ADDENDUM NO. 1

PROJECT: OLV Human Services
Rev-Up! Renovations

CPL PROJECT NO. 16128.00

DATE: April 28, 2022

1 FIRST FLOOR PLAN
A200 1/8" = 1'-0"
TRUE NORTH

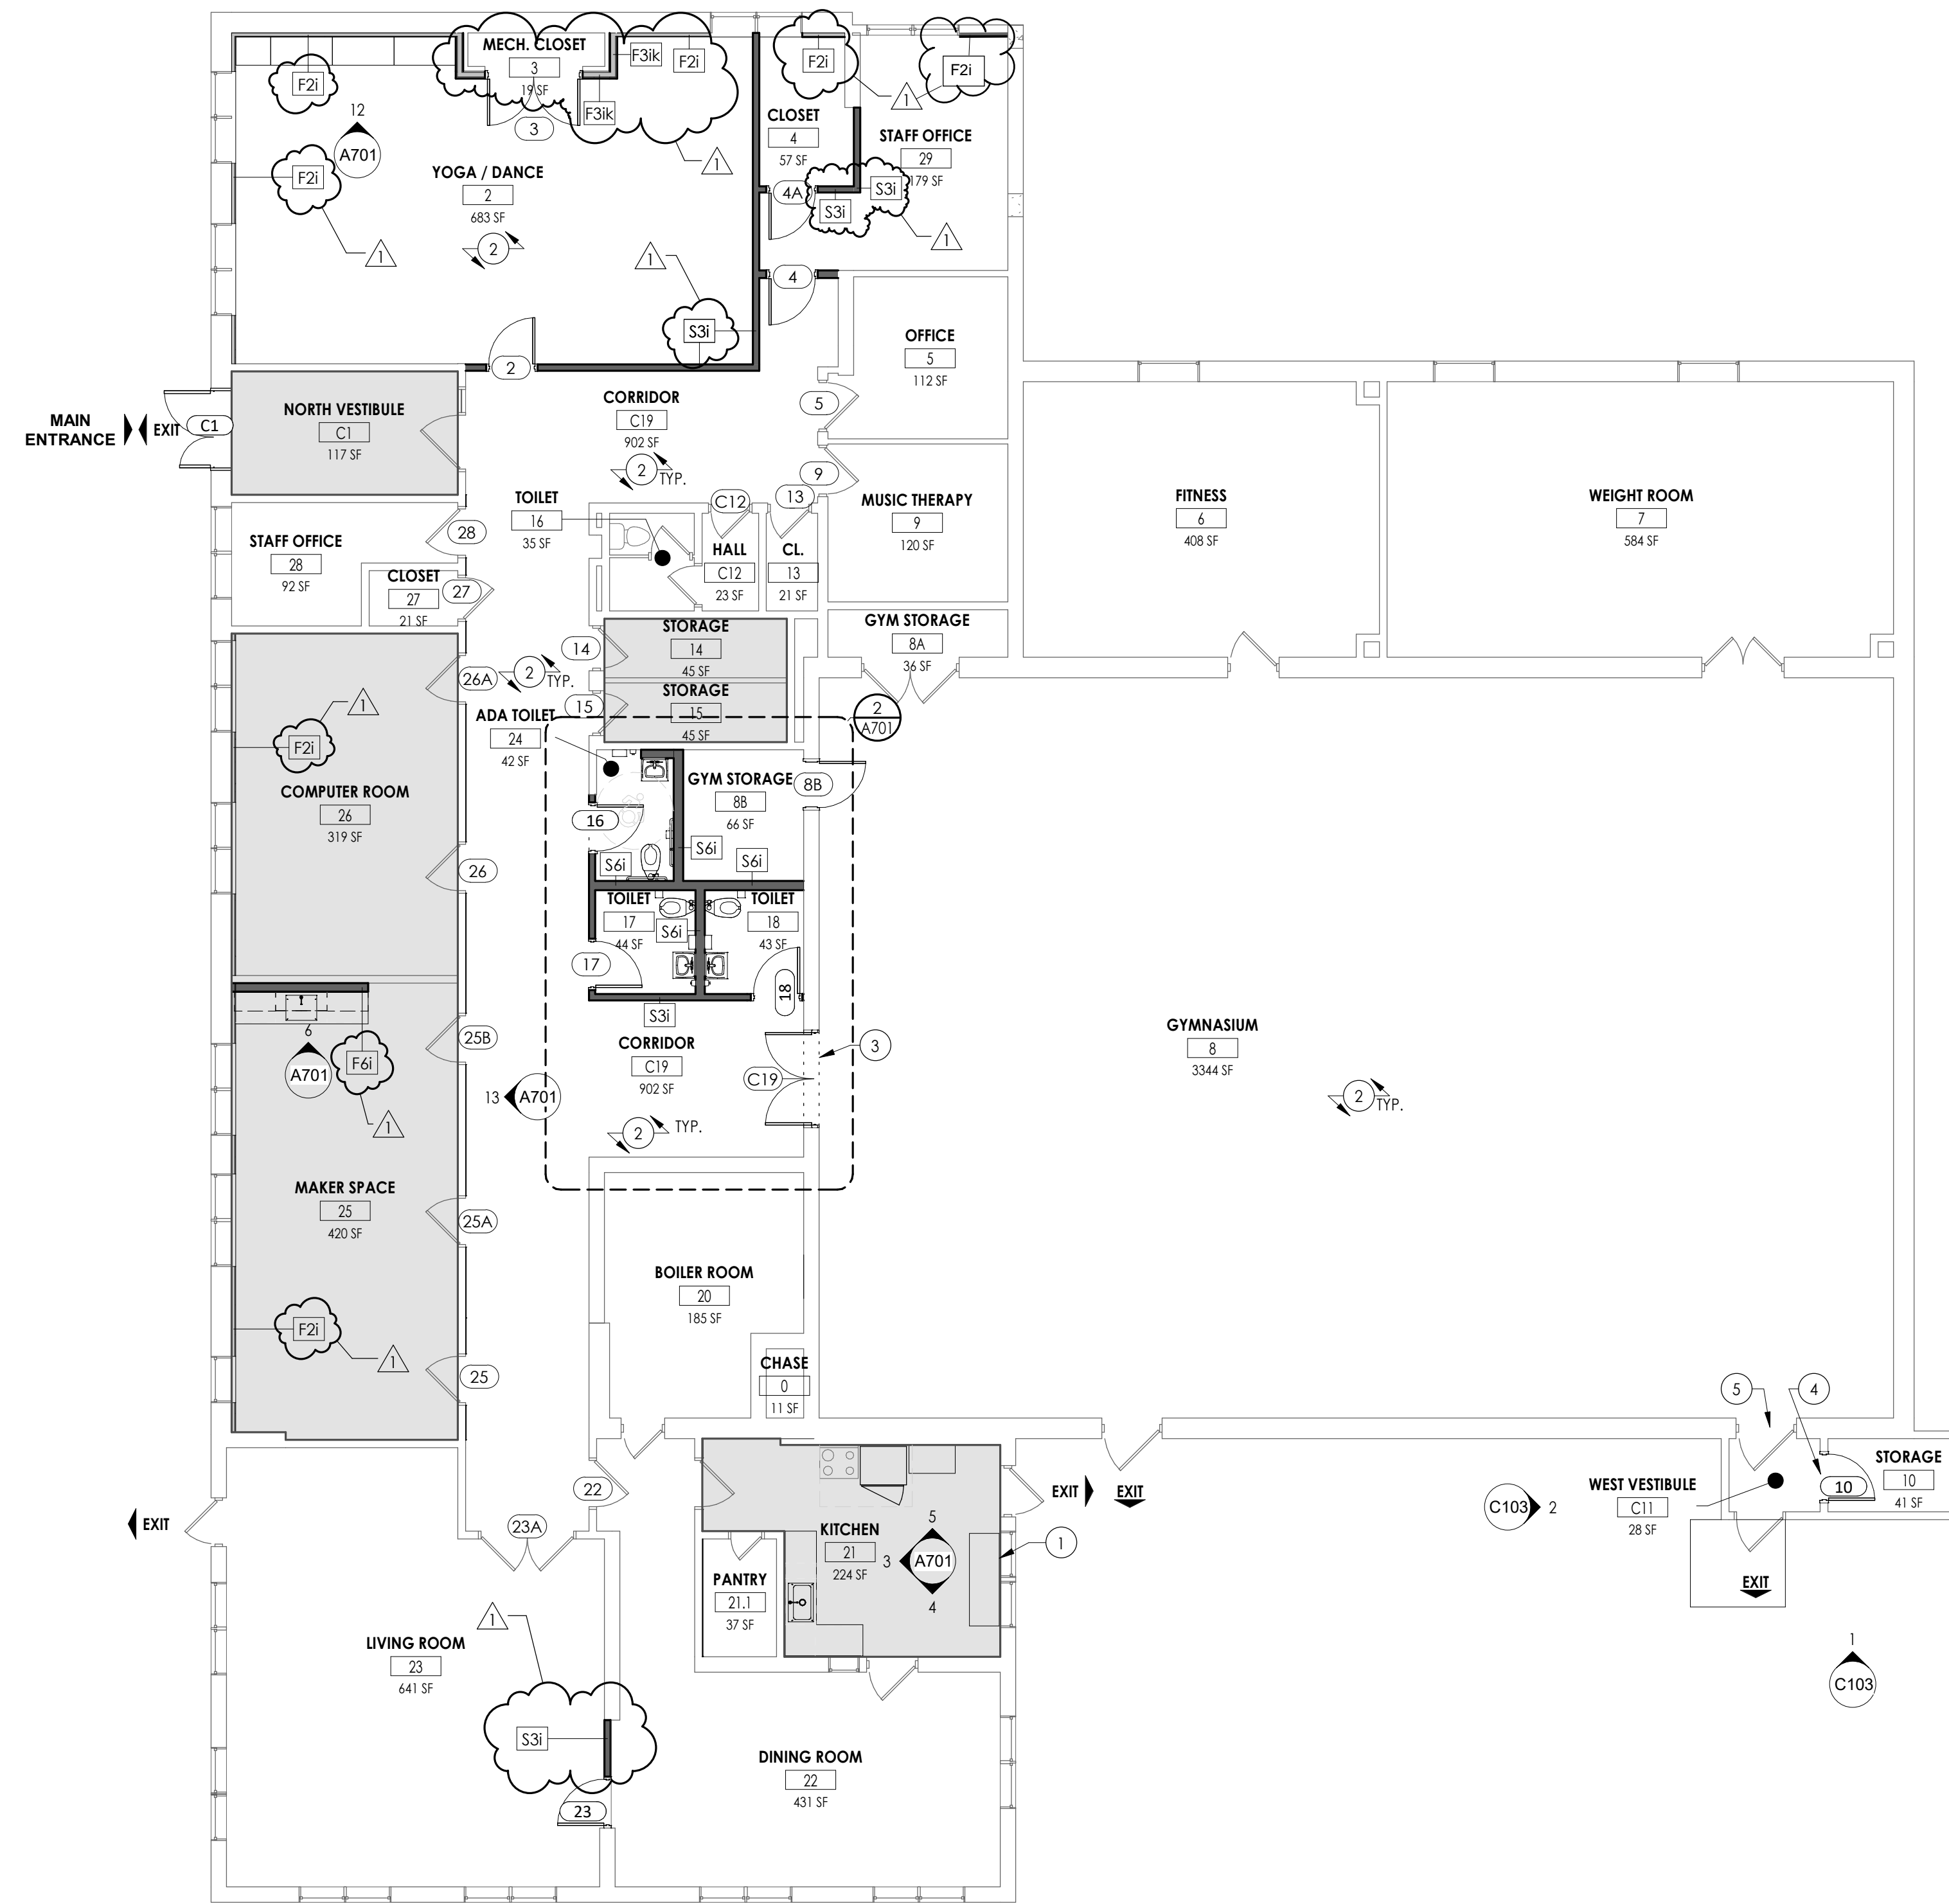
- **Replace** drawing in its entirety, with the attached revised drawing.
- Revisions include changes to partition types.

TYPE	STC TEST NUMBER &/OR FIRE TEST LAB DESIGN TEST NUMBER	FIRE RATING	STC	NOTES
F3K	NGC 2013013	NR	65	SMOKE/ACOUSTICAL SEALANT AT TOP AND BOTTOM

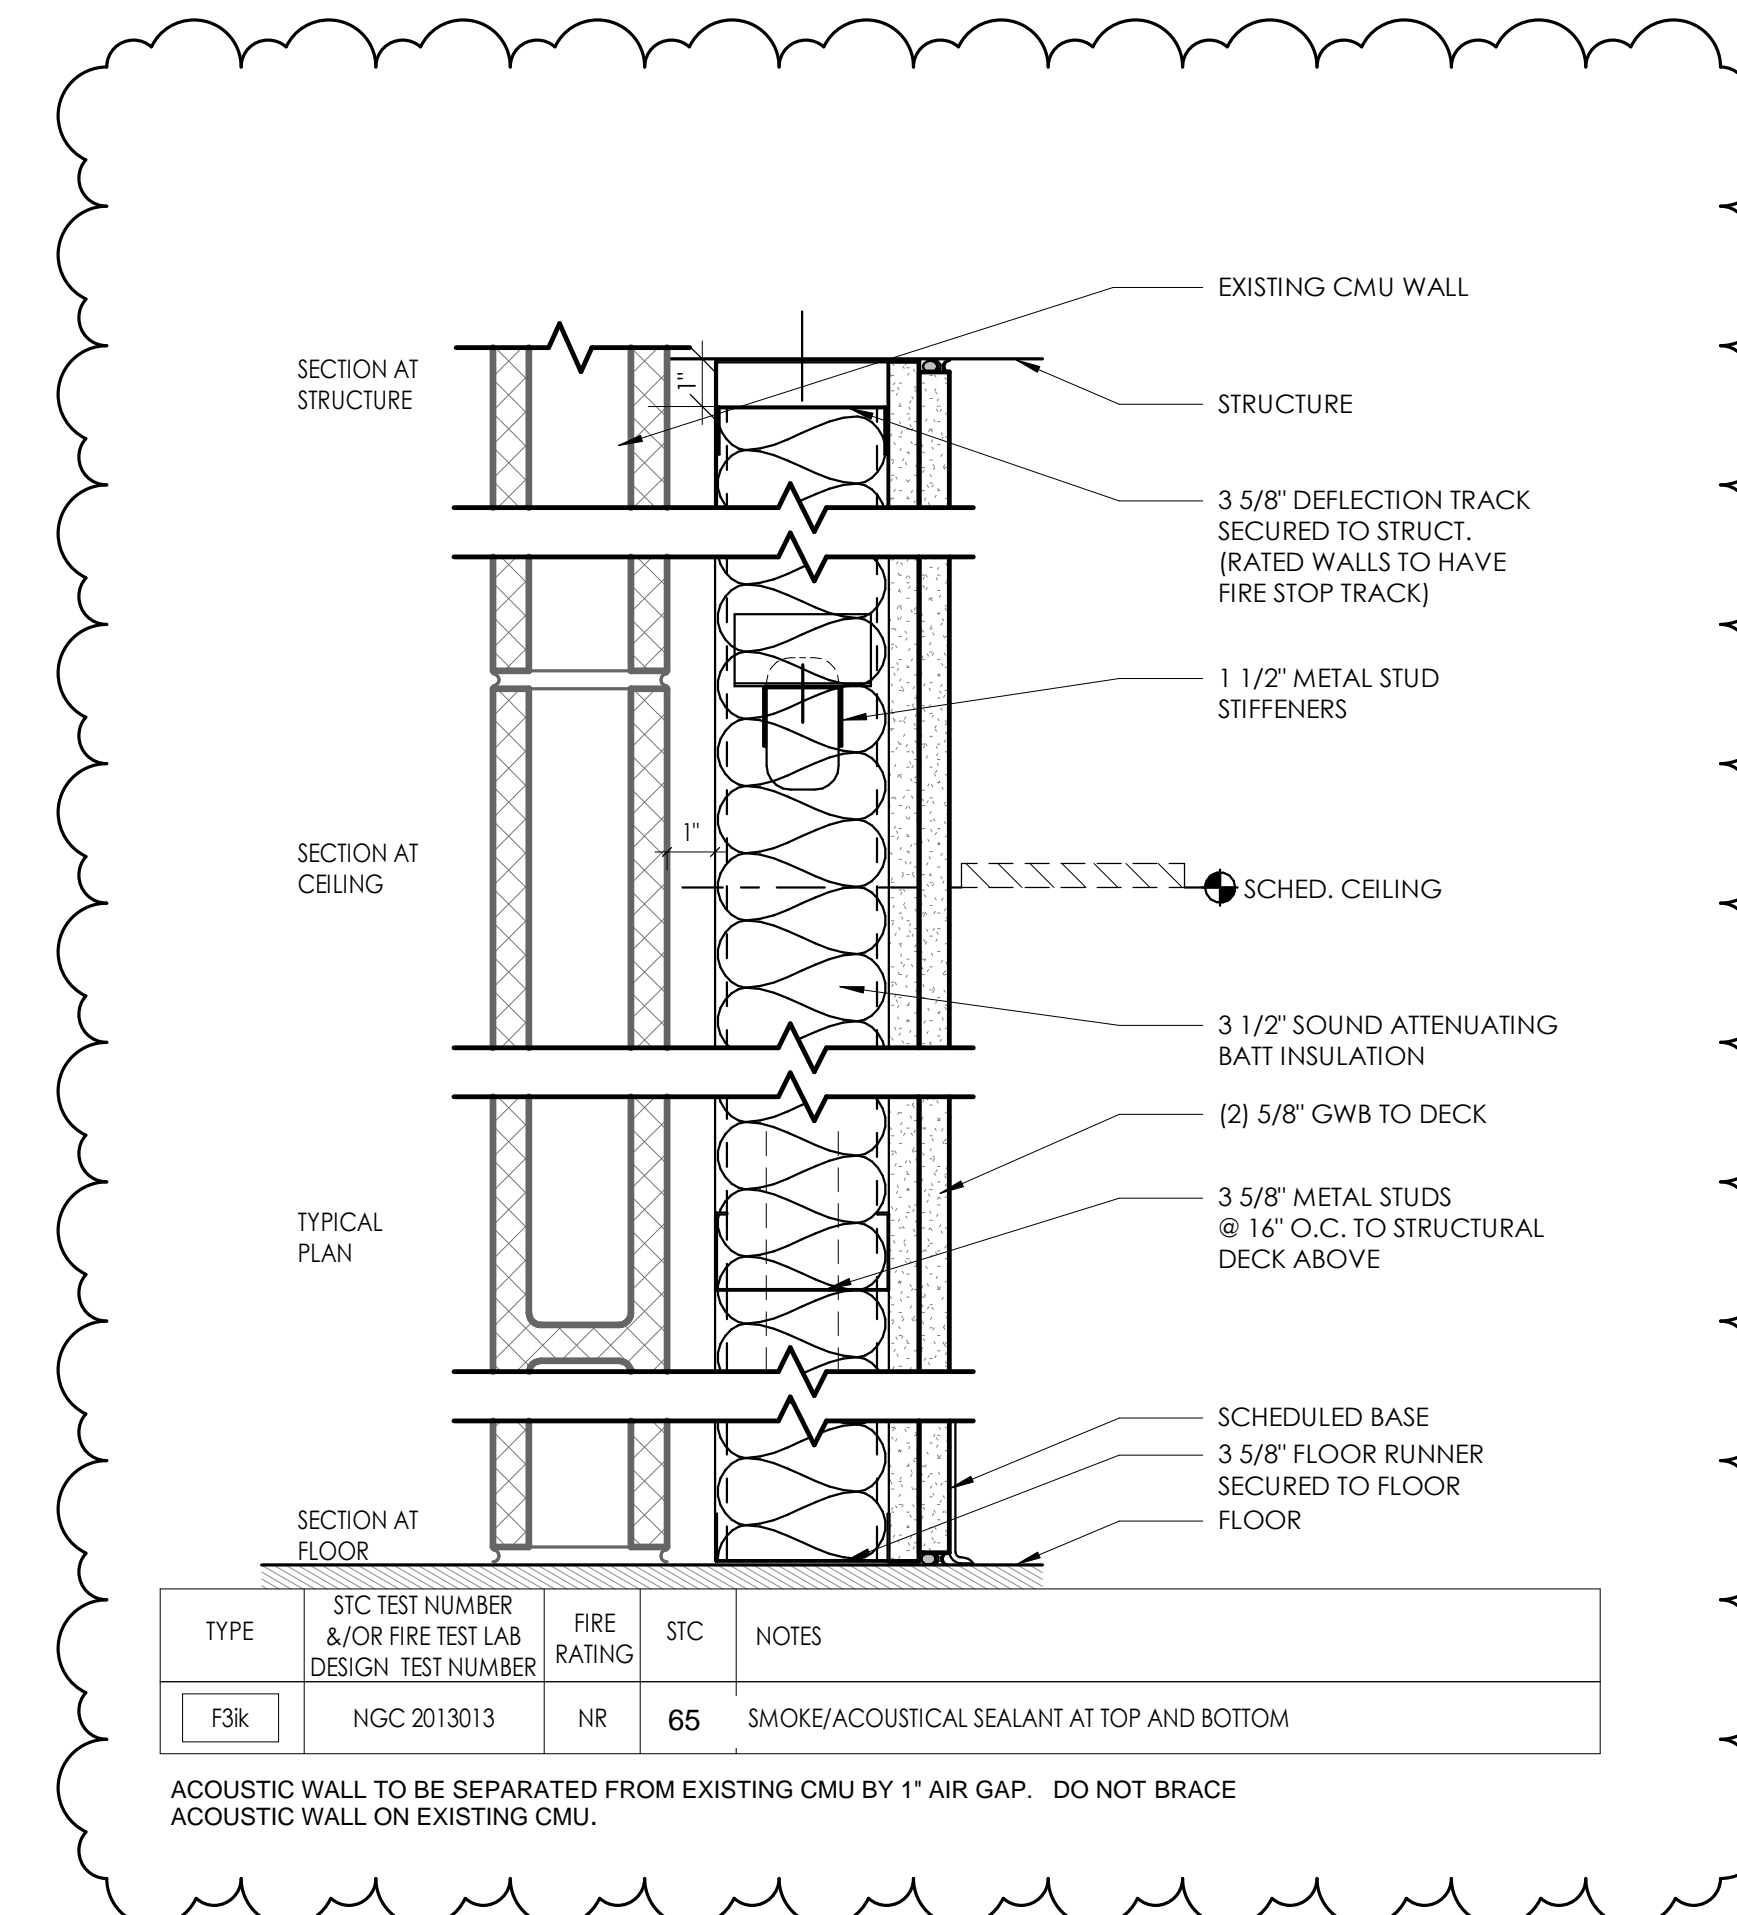
- **Replace** drawing in its entirety, with the attached revised drawing.
- Revisions include addition of acoustic partition type F3ik.

1 FIRST FLOOR POWER AND SYSTEMS PLAN
1/8" = 1'-0"

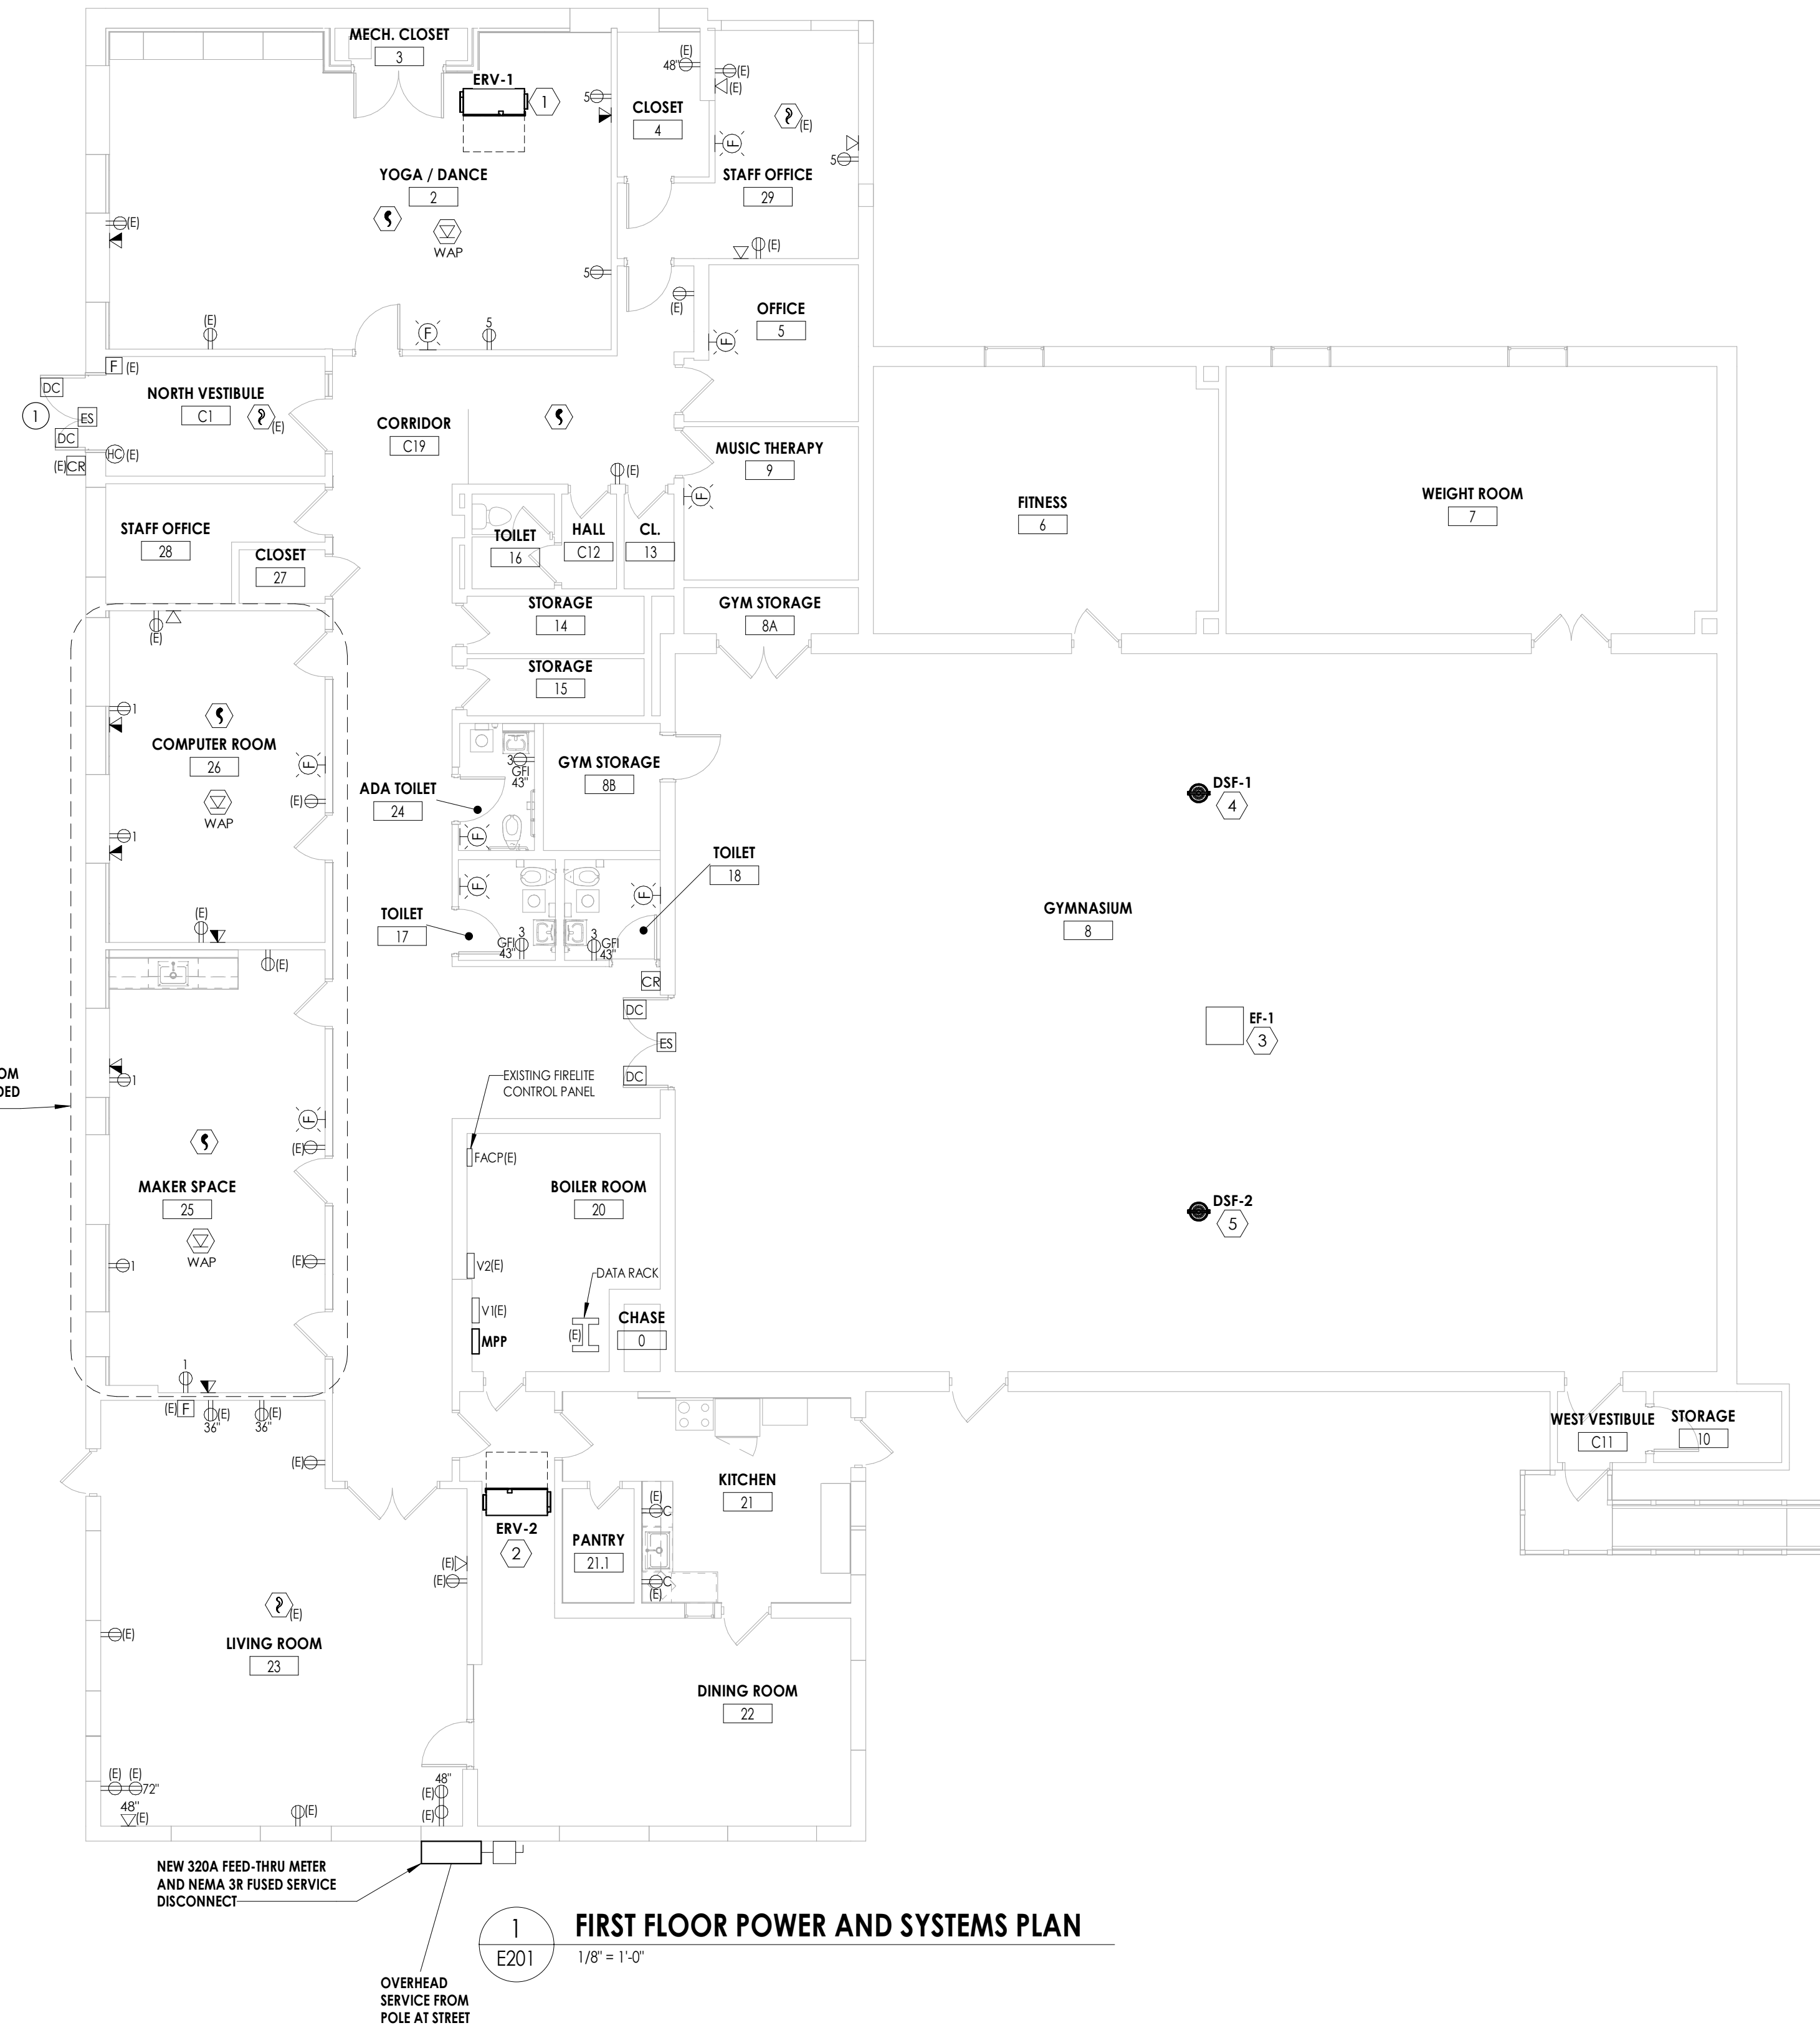
- **Replace** drawing in its entirety, with the attached revised drawing.
- Revisions include change in General Note G reference from accessible ceilings for hard ceilings.
